[Docket No. FAA-2006-25105; Directorate Identifier 2006-CE-33-AD; Amendment 39-14982; AD 2007-06-01]

Airworthiness Directives; Raytheon Aircraft Company Beech Models 45 (YT-34), A45 (T-34A, B-45), and D45 (T-34B) Airplanes

ACTION: Final rule.

KEY	PART NO.	DESCRIPTION	SIZE	MATERIAL SPEC.	HEAT TREAT	NOTES
2	45-127-2	BUSHING TOOL	Ø0.44(DIA) x1.75	ALUMINUM		BREAK ALL SHARP EDGES
1	45-127-1	BUSHING TOOL	Ø0.38(DIA) x1.75	ALUMINUM		BREAK ALL SHARP EDGES

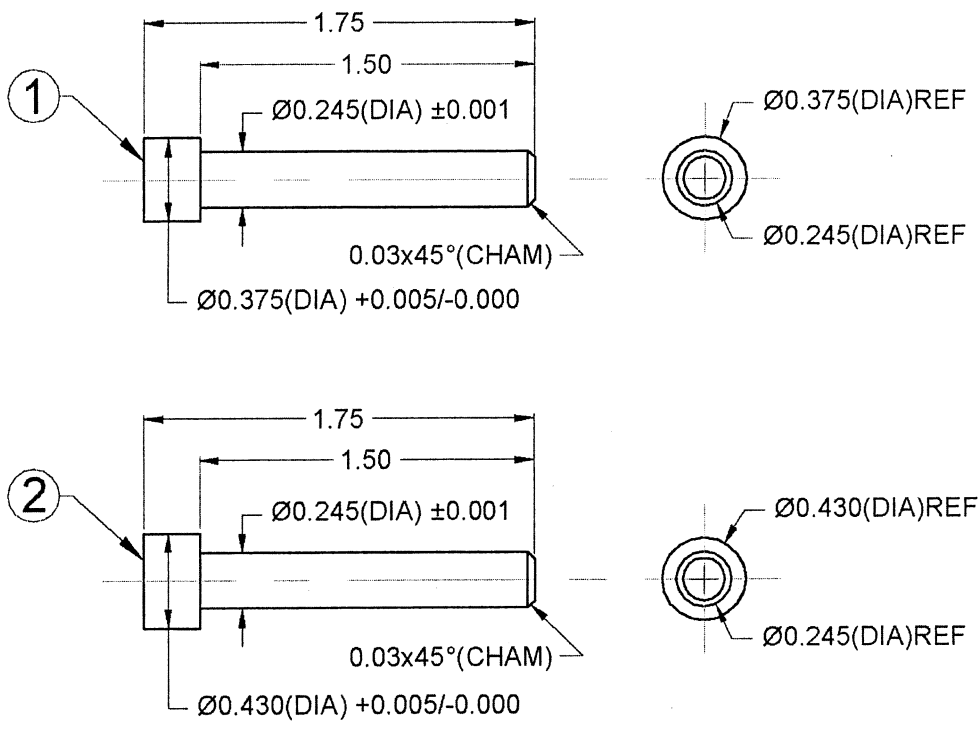
REVISIONS			
REV	DESCRIPTION	DATE	APPROVED
A	CHANGED TO BE MADE INTO TWO SEPERATE PARTS	3-10/05	D. LANGRETH
